PPA Resolution

TO: Cam Gordon, City of Minneapolis Council Member, Ward 2
RE: Prospect Park Association resolutions regarding Vermilion Development Art & Architecture

Resolution regarding Vermilion Development Art & Architecture PUD

Project Change Clarifications

North and South Elevations

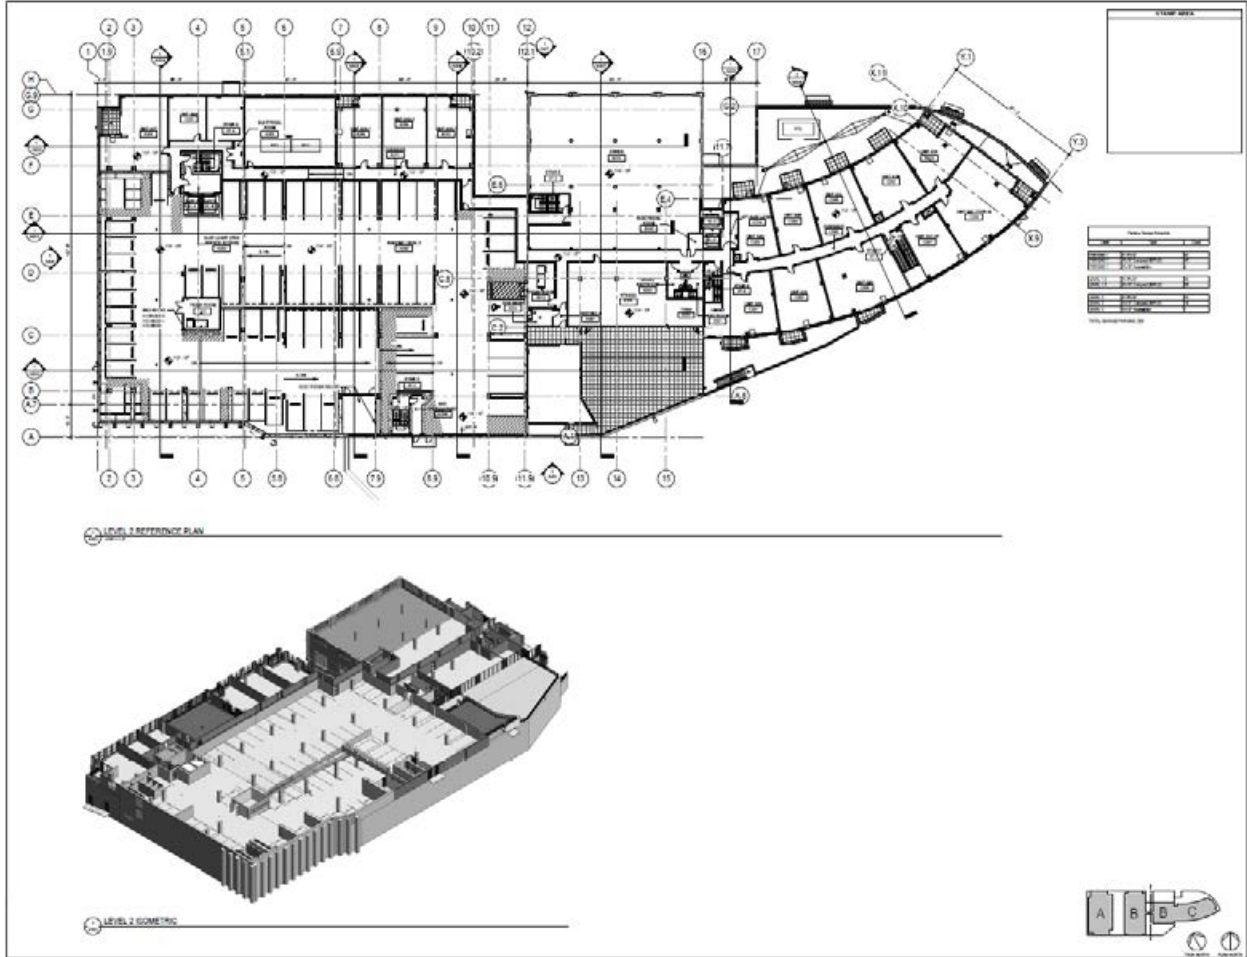
2b. In it's north elevation, the building tends to have a more uniform or blocky appearance, particularly with the reduction in the stepping action. This was not met with approval. The small scale of the elevation drawings probably added to the confusion and we were wondering if it is possible for the architect to provide some birds-eye perspectives from different vantage points - particularly from the northeast and east so we have a better view of the Bedford-University Ave. intersection and the stepping action of the building.

We understand that it is difficult to visualize in 3D from the north elevation image provided in our project update. That image does not capture the curvature of both the site and the architecture. While we unfortunately cannot commission additional renderings at this time, please see the

drawings located in the PPA offices to better understand the curvature of the eastern portion of the building.
